Red Clay Consolidated School District
AI DuPont Middle School HVAC Renovations
Bid Pac "A"

ADDENDUM #1 ISSUED BY EDiS COMPANY
110 S. POPLAR STREET, WILMINGTON, DE 19801

PARTIAL BOILER ROOM DEMOLITION PLAN

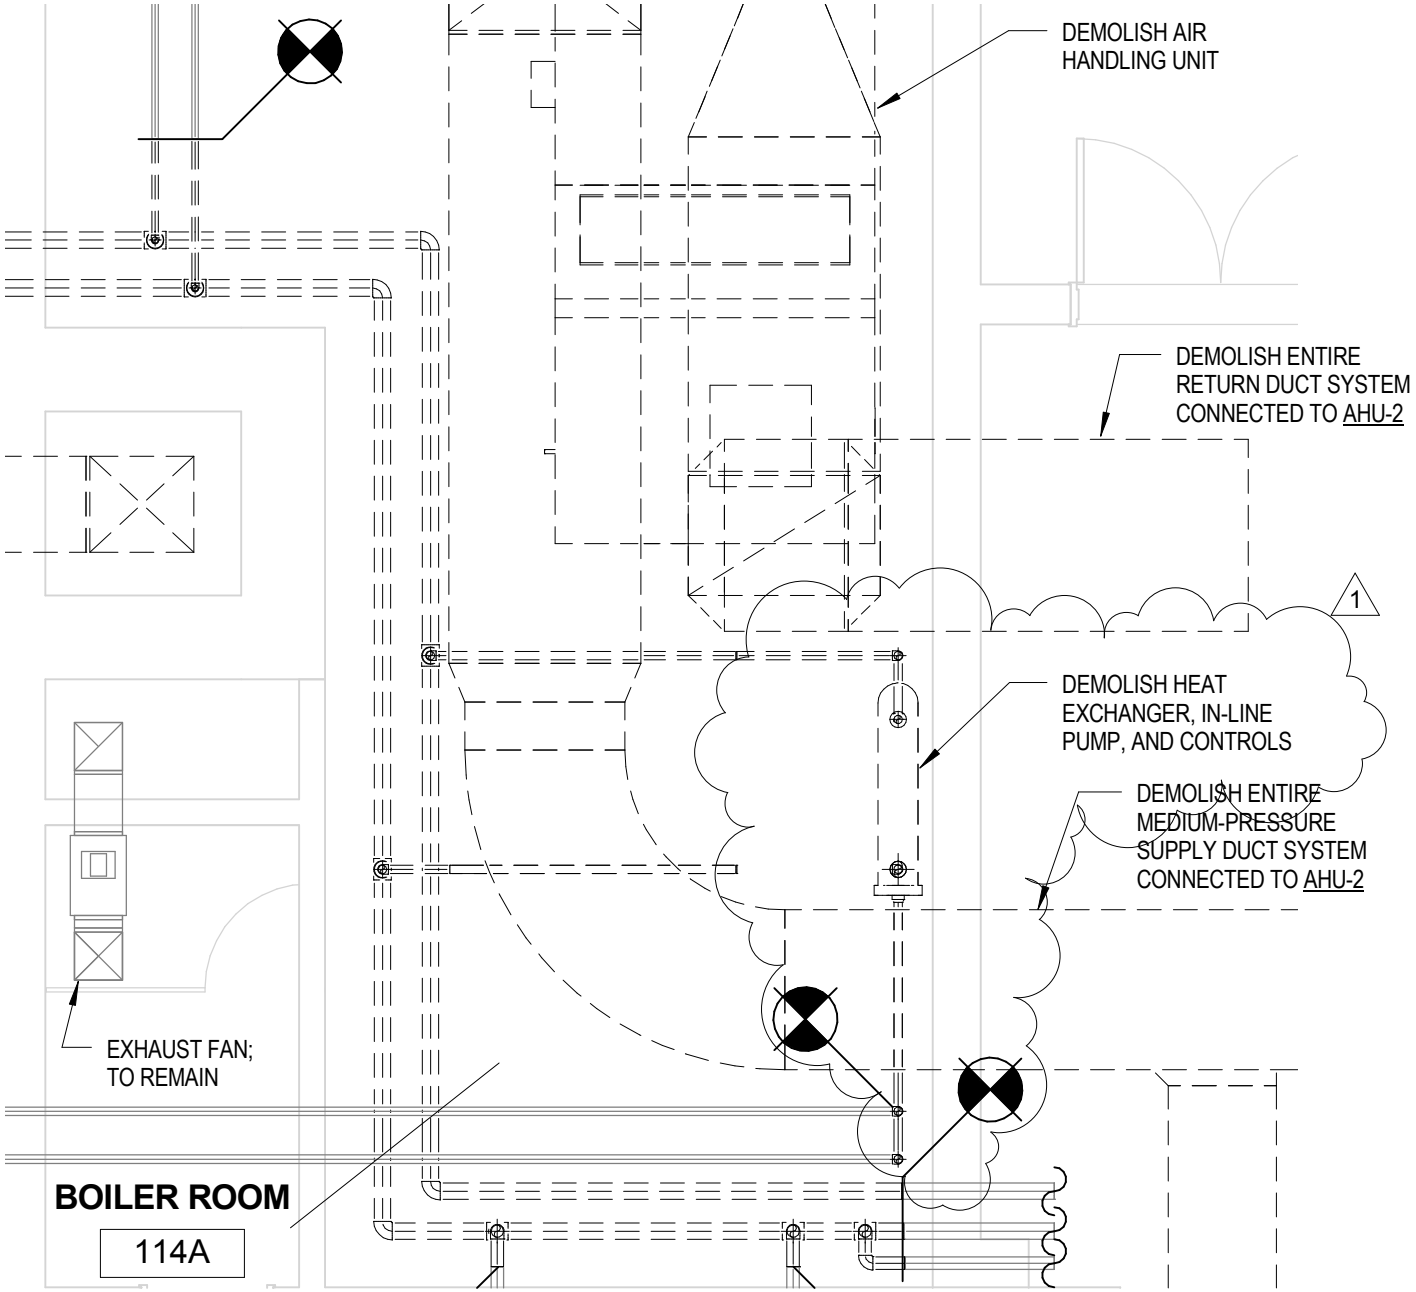
20. Drawing M8.27 – Add demolition of heat exchanger, pump, and piping. See sketch SK-M.13.
21. Drawing M8.27 – Add heat exchanger HX-1, add P-3, and add associated piping. See sketch SK-M.14.
22. Drawing M8.27 – Add Typical HX Detail. See sketch SK-M.15.
23. Drawing M8.29 – Add Gasketed Plate Heat Exchanger Schedule. See sketch SK-M.16.
24. Drawing M.8.28- Revise Pump Schedule. See sketch SK-M.17.

SK-E.1

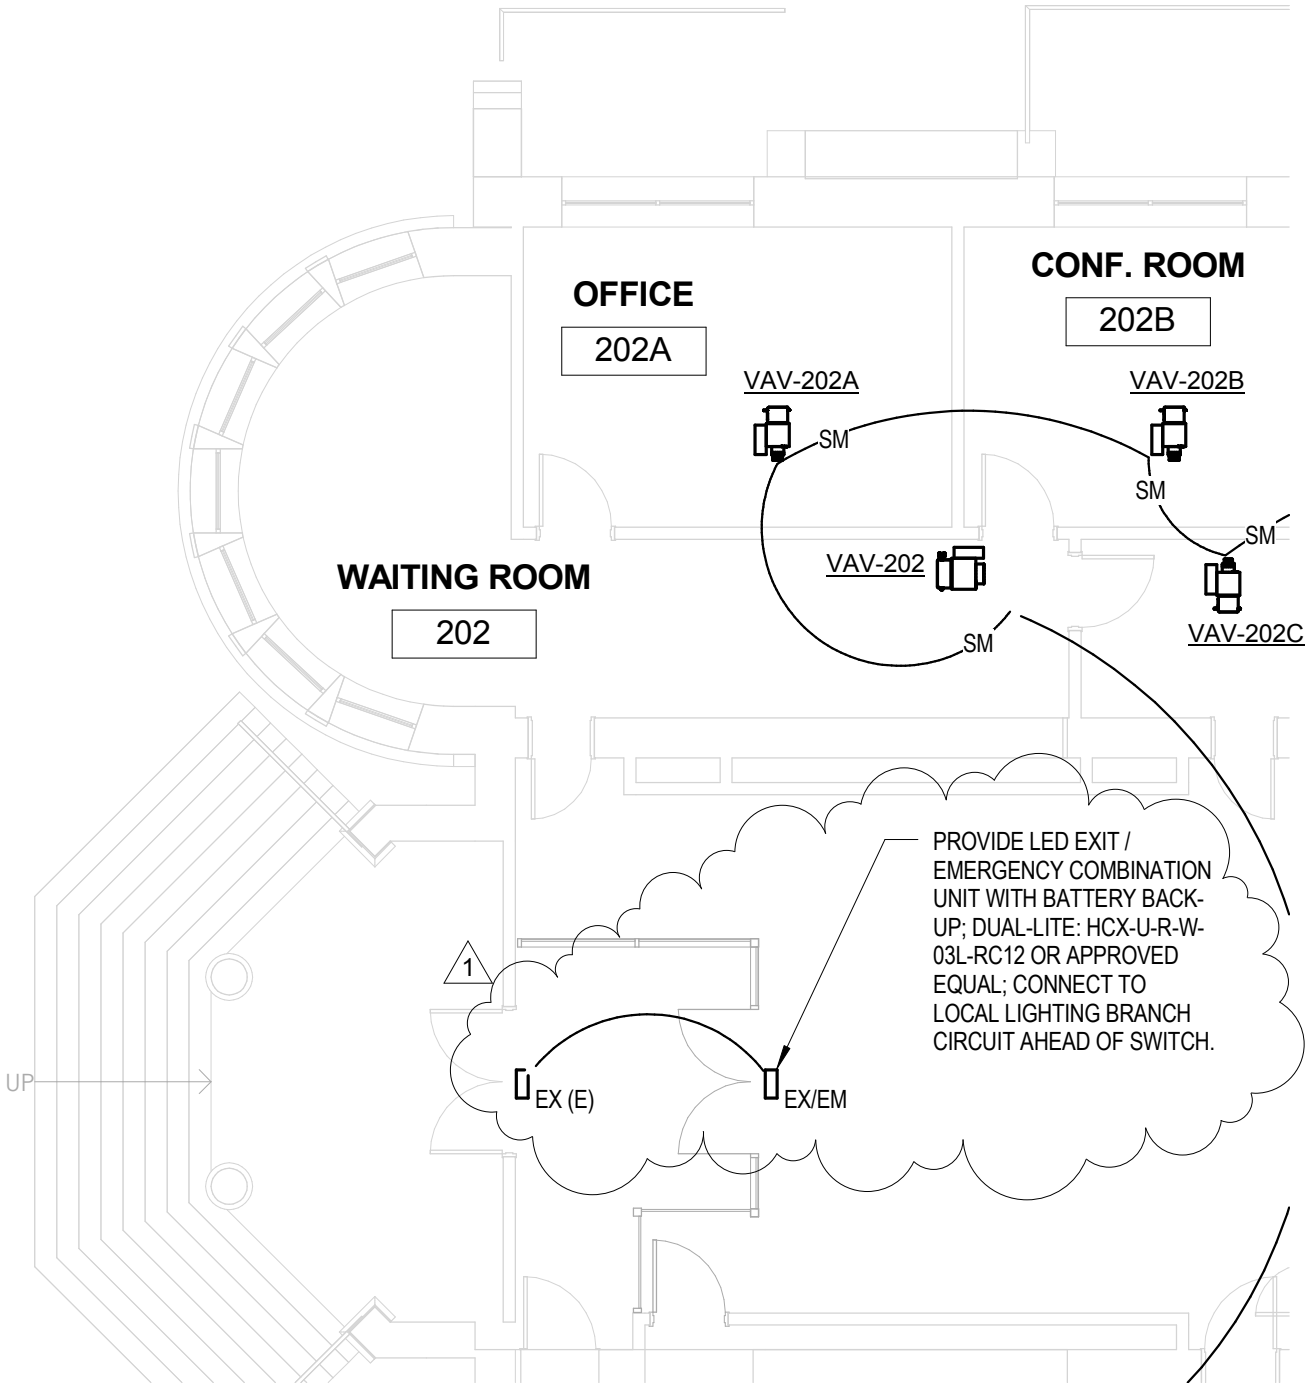
1. Drawing E9.12 – Add exit / emergency light combination fixture at front entrance. See sketch SK-E.1.
2. Drawing E9.23 – Revise panel schedule for Branch Panel: A. See sketch SK-E.2.

1
SK-E.3

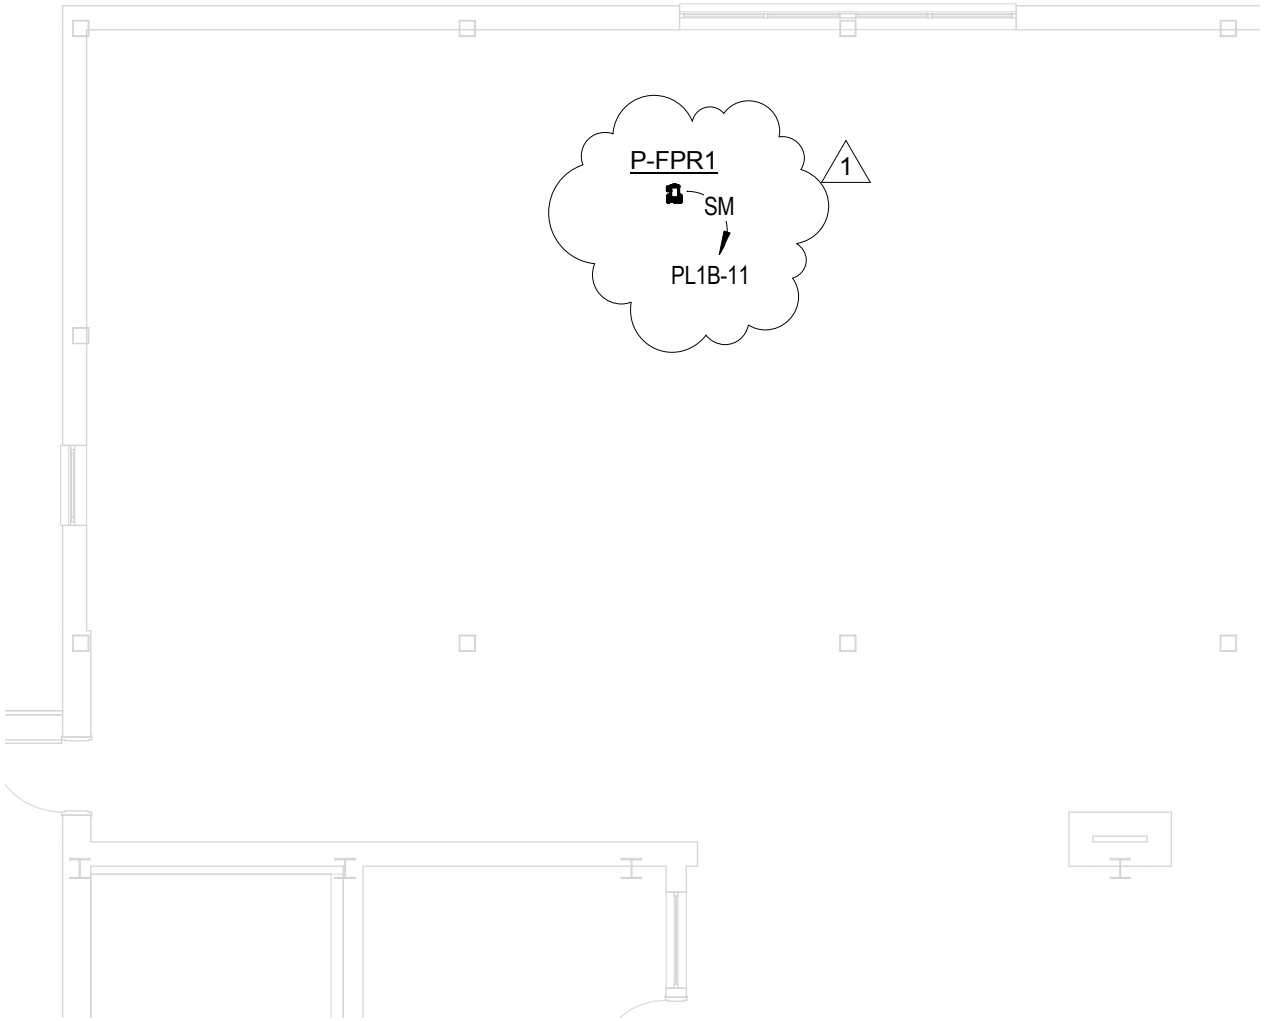
7. Drawing E9.13 – Add circuit for freeze protection pump P-FPR1. See sketch SK-E.3.
8. Drawing E9.14 – Add circuit for freeze protection pump P-FPD1. See sketch SK-E.4.

SK-E.7

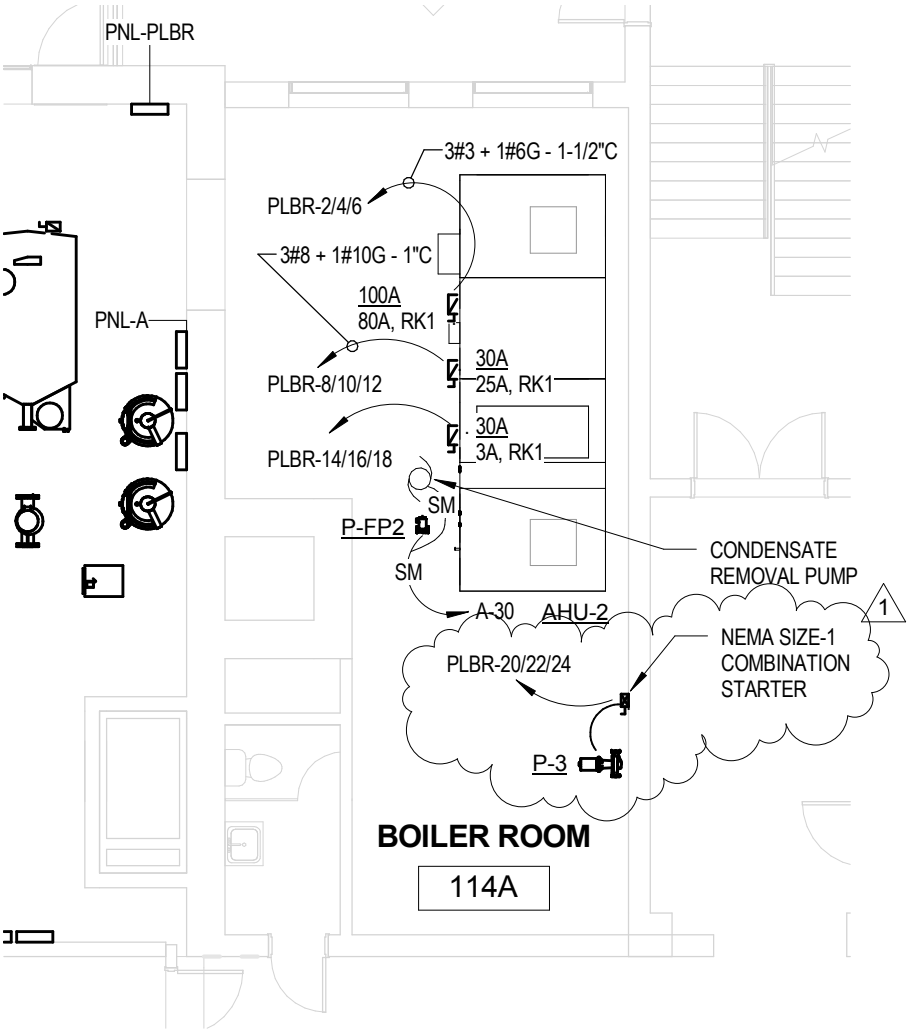
11. Drawing E9.11 – Add circuit for pump P-3. See sketch SK-E.7.
12. Drawing E9.23 – Add pump P-3 to Panel Schedule PLBR. See sketch SK-E.8.
13. Drawing E9.2 – Revised drawing to show outlets to be removed/replaced in demo of sound proofing material.
